TITLE: SUNDORO SOUTH UNIT
GRADING & DRAINAGE PLAN
ENGINEER'S CERTIFICATION

TITLE:
SUNDORO SOUTH UNIT 5
GRADING & DRAINAGE PLAN

DRAINAGE CERTIFICATION

TITLE: SUNDORO SOUTH UNIT 6
GRADING & DRAINAGE PLAN
ENGINEERS CERTIFICATION

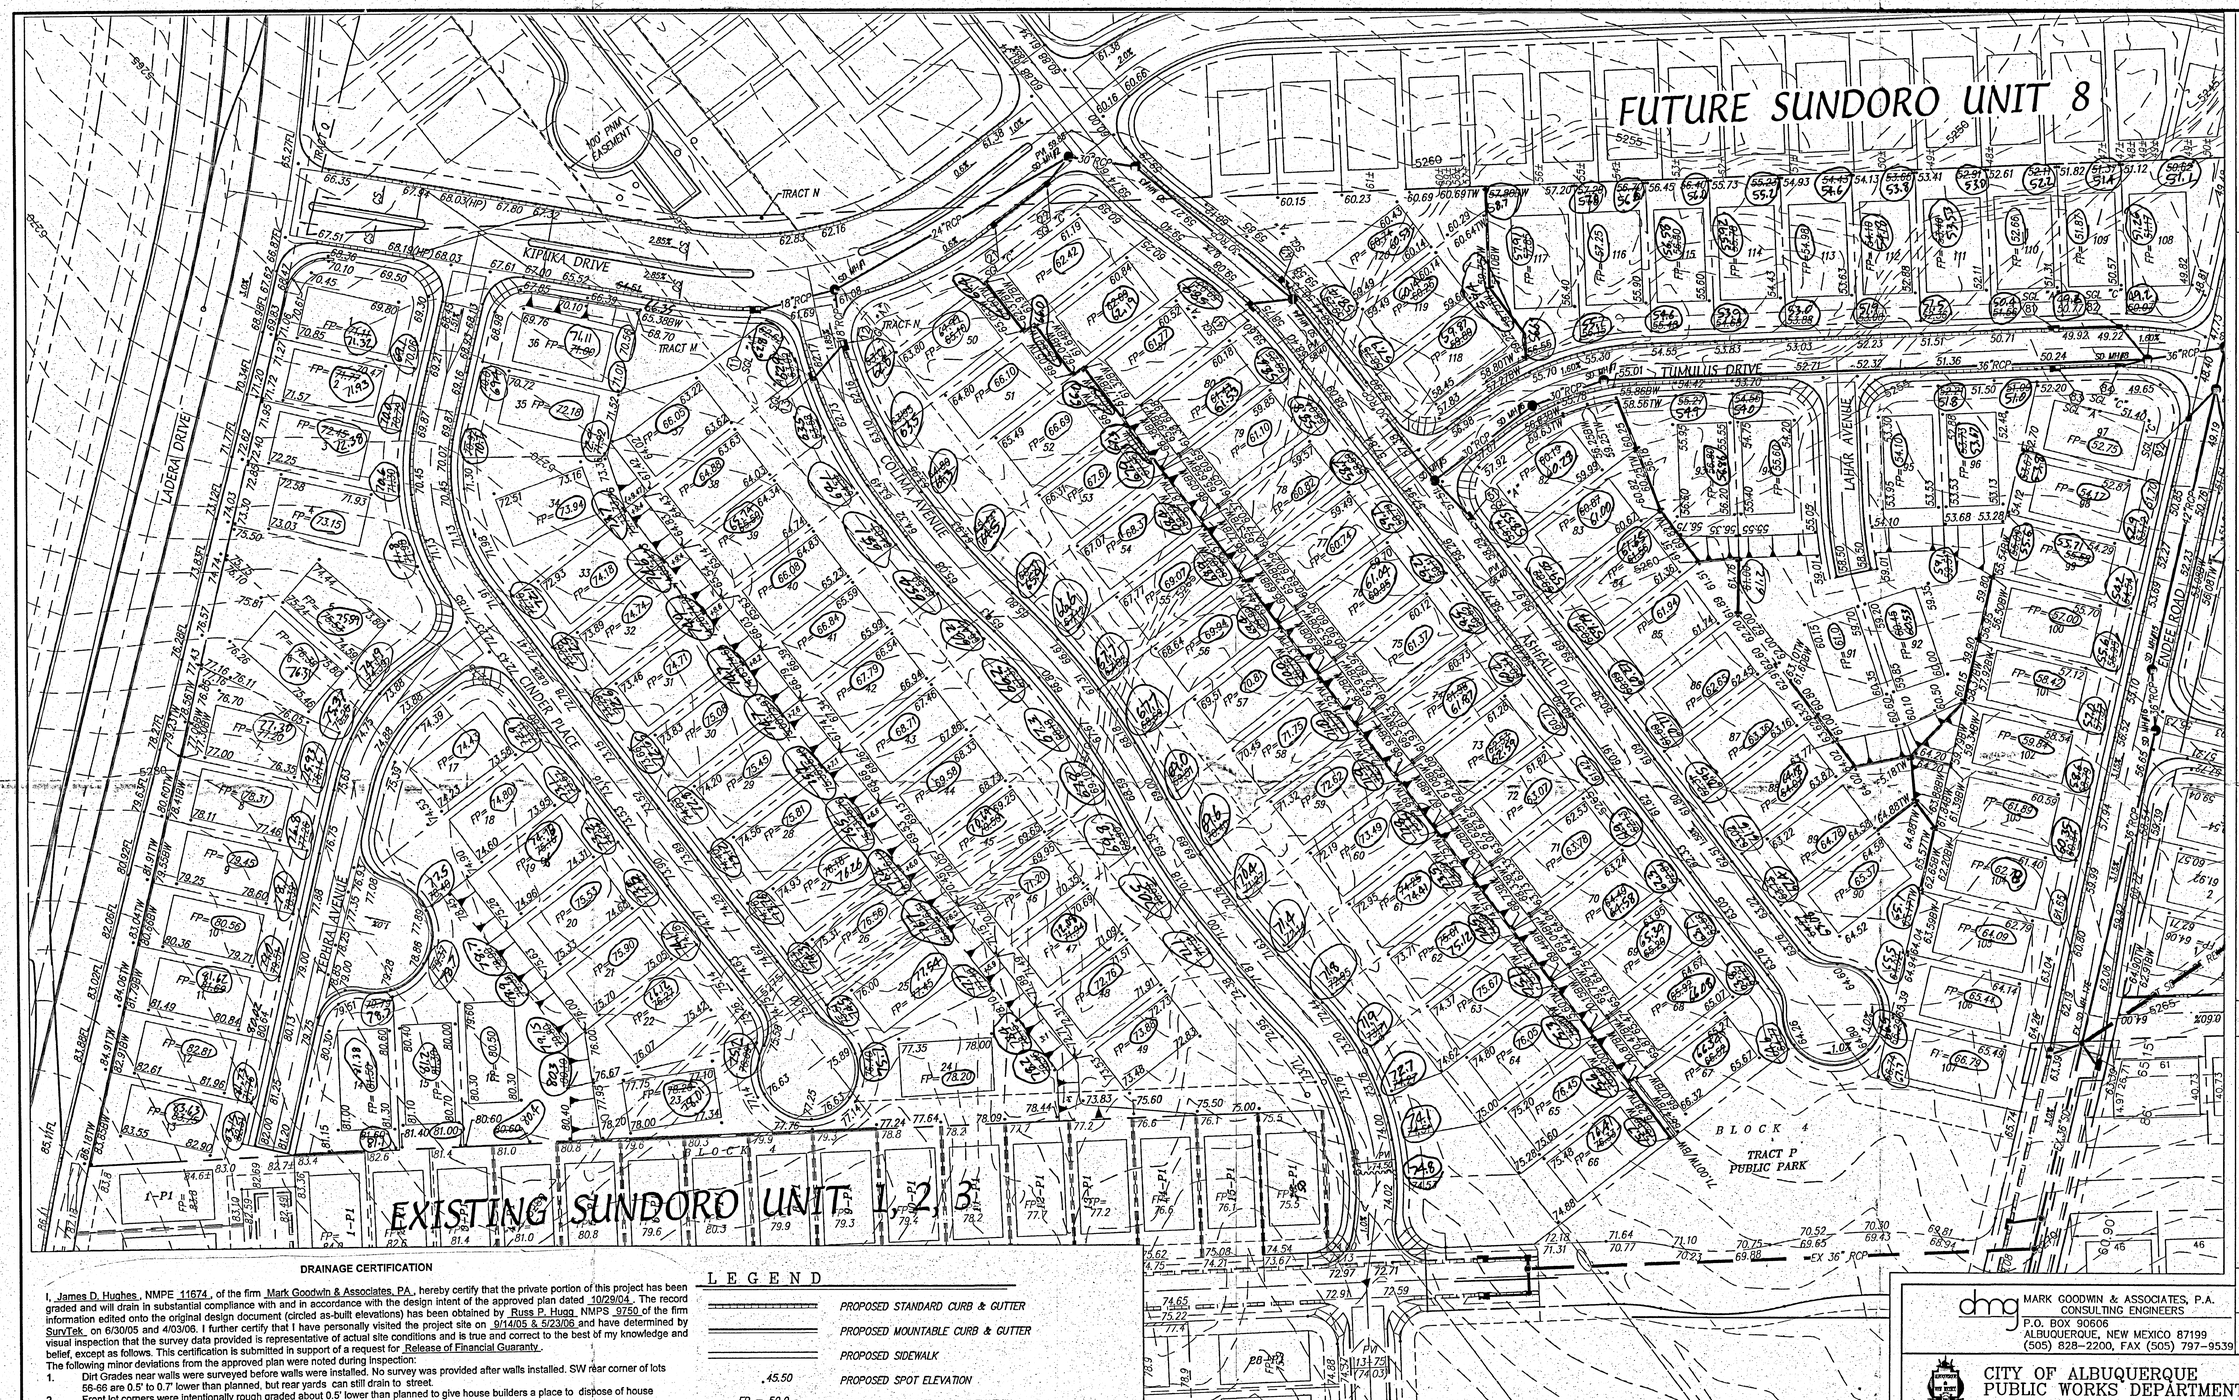
The following minor deviations from the approved plan were noted during inspection:

1. Dirt Grades near walls were surveyed before walls were installed. No survey was provided after walls installed. SW rear corner of lots 56-66 are 0.5' to 0.7' lower than planned, but rear yards can still drain to street.

2. Front lot corners were intentionally rough graded about 0.5' lower than planned to give house builders a place to dispose of house footer excavation and in anticipation of subgrade for the builder constructed deferred sidewalks.

3. Grading on Park Tract P destroyed emergency overflow swale that was constructed from the south end of Vellarrica St. to Endee Rd. The swale must now be restored to prevent drainage into Unit 5. All disturbed areas on the Park still need to be seeded and mulched per the SWPPP.

4. The common swales were missing on lots 64-66 where the front yard drainage needs to be directed to the street and not the park.
5. Walls on side and rear lot lines on lots 82-104 were constructed where they retain dirt. They were not constructed where they don't retain. The builder can complete fine grading and wall construction to drain according to plan.

6. A retaining wall is needed on the East side of lots 108-120 which will be constructed by mutual agreement between Westland and the developer of Sundoro Unit 8, which is still being graded.

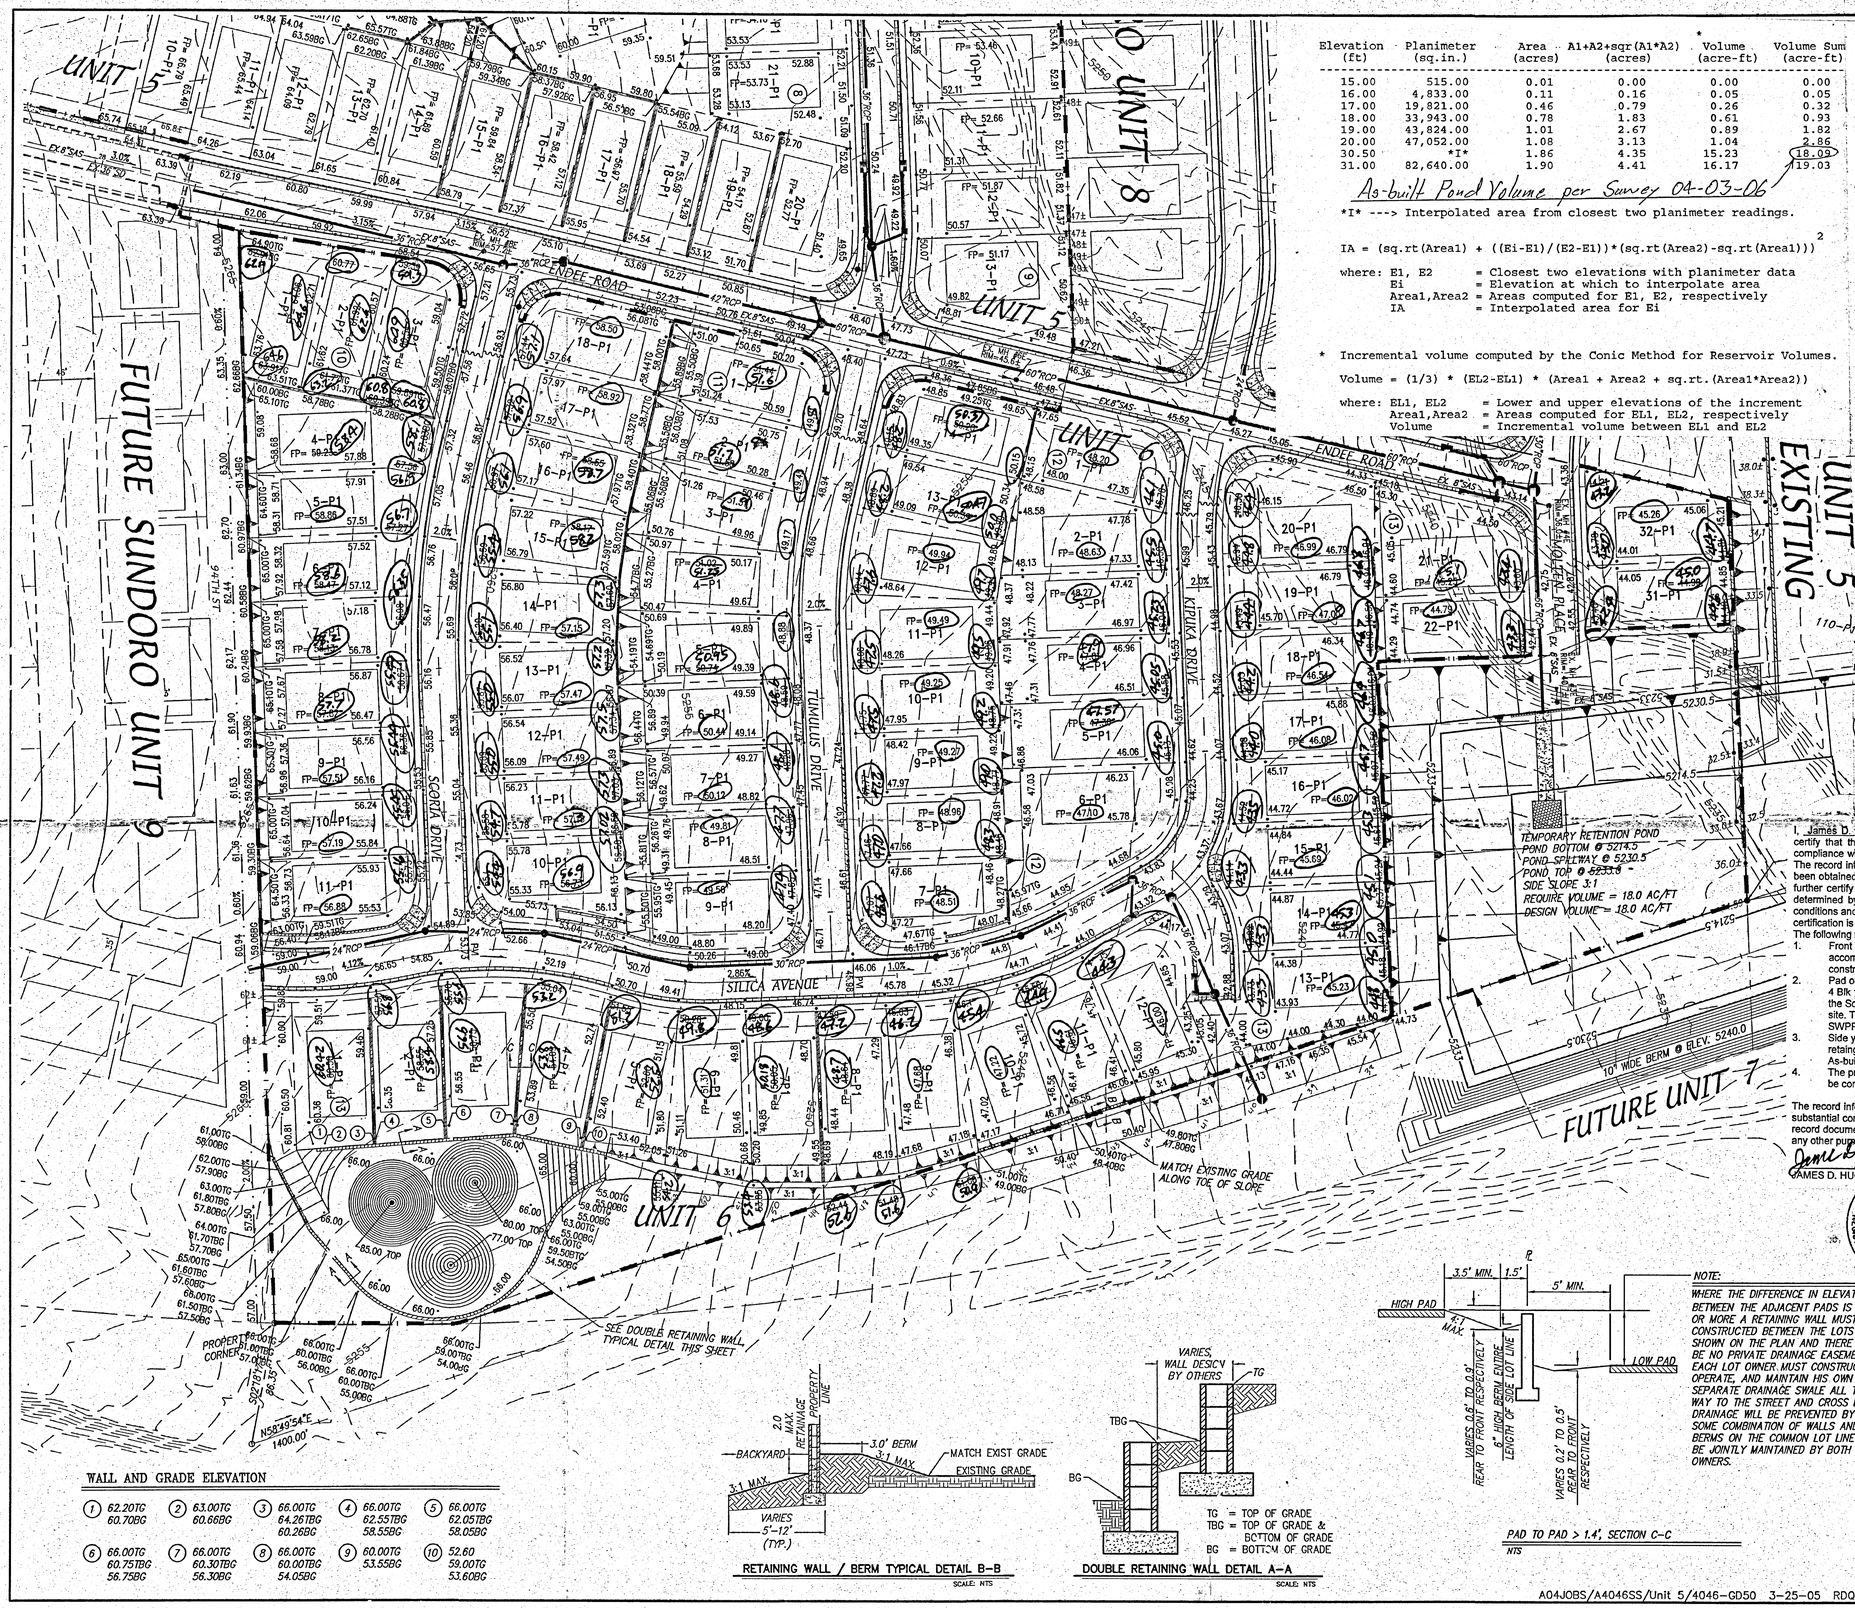
As-built Pond Volume per Survey 04-03-06

The following minor deviations from the approved plan were noted during inspection:

1. Front lot corners were intentionally graded about 0.5' lower than planned to accommodate Home Builders need to dispose of excess dirt from house footers and construction of deferred sidewalks.

2. Pad on Lot 2 Blk 10 is 0.7' higher than planned and SW corner is 1.6' higher. Pad on Lot 4 Blk 10 is 0.8' lower than planned. Grading of the "entry Sign" on the HOA Tract in the Southwest corner of the site is still in progress with dirt stockpiled around the sign site. The are will be stabilized by the developer after grading is complete per the SWPPP.

3. Side yard retaining walls were missing on both sides of lot 4 Blk 13 and lot 7 Blk 13. The retaing wall at the rear of lots 10 & 11 Blk 13 was not backfilled to the planned grade. As-built grades near retaining walls were surveyed before wall construction.

4. The private pond is in substantial compliance with the plan. Seeding and mulching is to be completed per SWPPP.

TITLE: SUNDORO SOUTH UNIT 5
GRADING & DRAINAGE PLAN

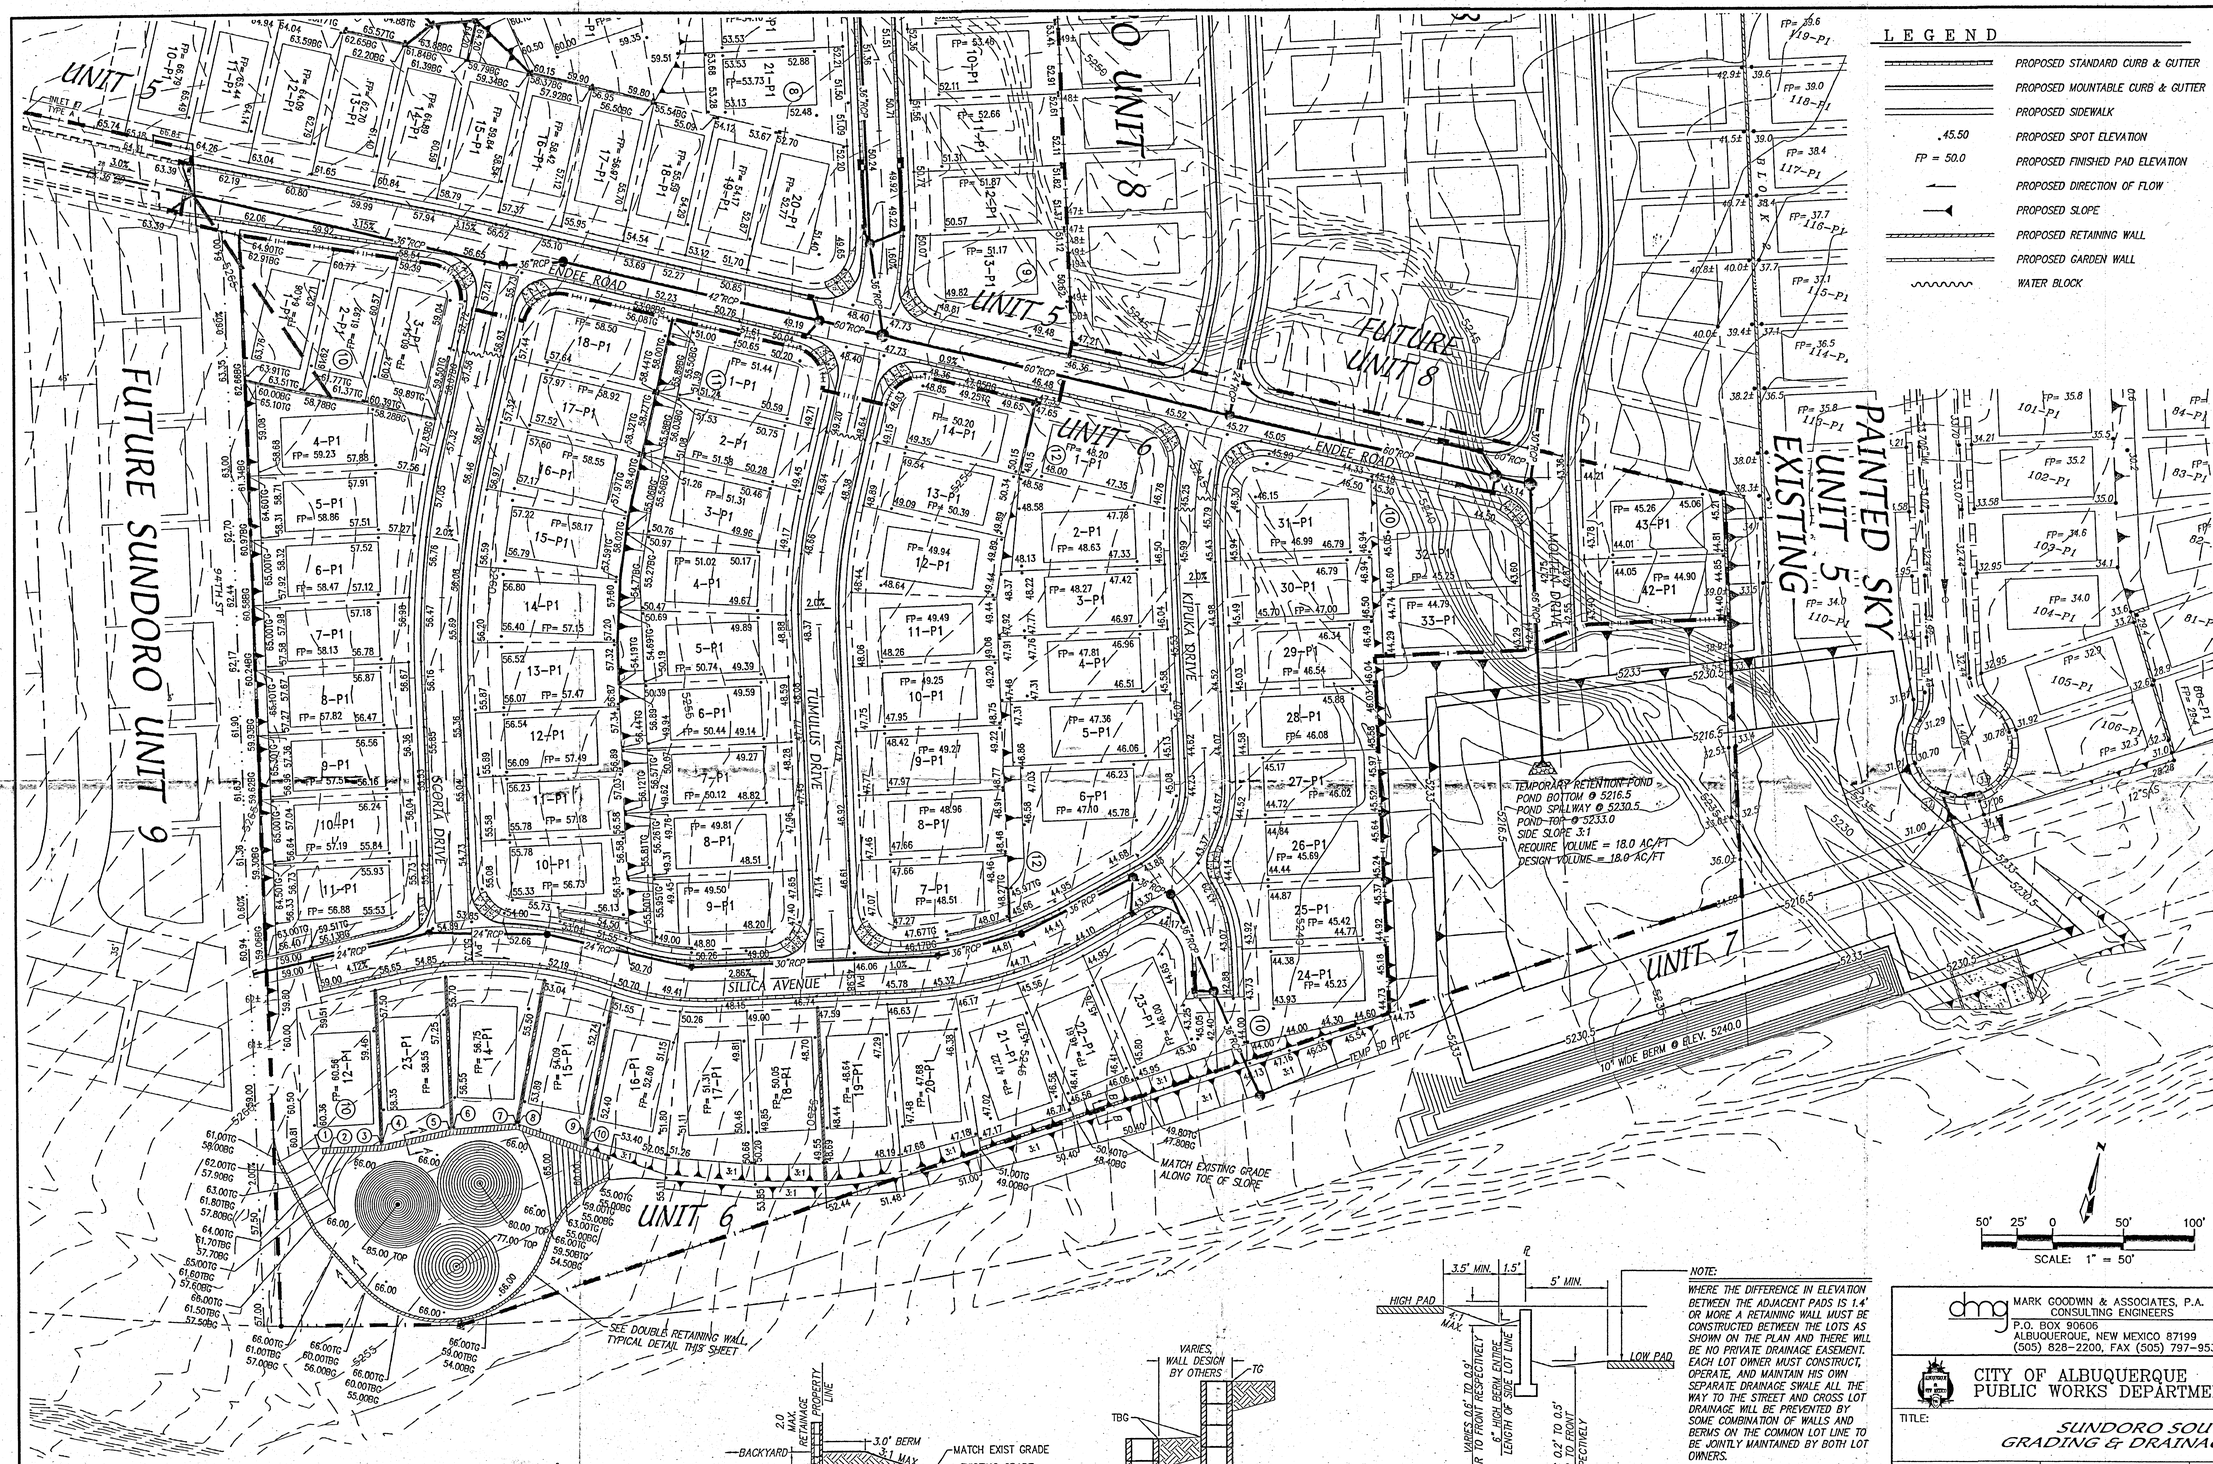
The following minor deviations from the approved plan were noted during inspection:

1. Dirt Grades near walls were surveyed before walls were installed. No survey was provided after walls installed. SW rear corner of lots 7-17 block 7 are 0.5' to 0.7' lower than planned, but rear yards can still drain to street.

2. Front lot corners were intentionally rough graded about 0.5' lower than planned to give house builders a place to dispose of house footer excavation and in anticipation of subgrade for the builder constructed deferred sidewalks.

3. Grading on Park Tract P destroyed emergency overflow swale that was constructed from the south end of Vellarrica St. to Endee Rd. The swale must now be restored to prevent drainage into Unit 5. All disturbed areas on the Park still need to be seeded and mulched per the SWPPP.

4. The common swales were missing on lots 15-17 block 7 where the front yard drainage needs to be directed to the street and not the park.
5. Walls on side and rear lot lines on lots in block 8 were constructed where they retain dirt. They were not constructed where they don't retain. The builder can complete fine grading and wall construction to drain according to plan.

6. A retaining wall is needed on the East side of block 9 which will be constructed by mutual agreement between Westland and the developer of Sundoro Unit 8, which is still being graded.
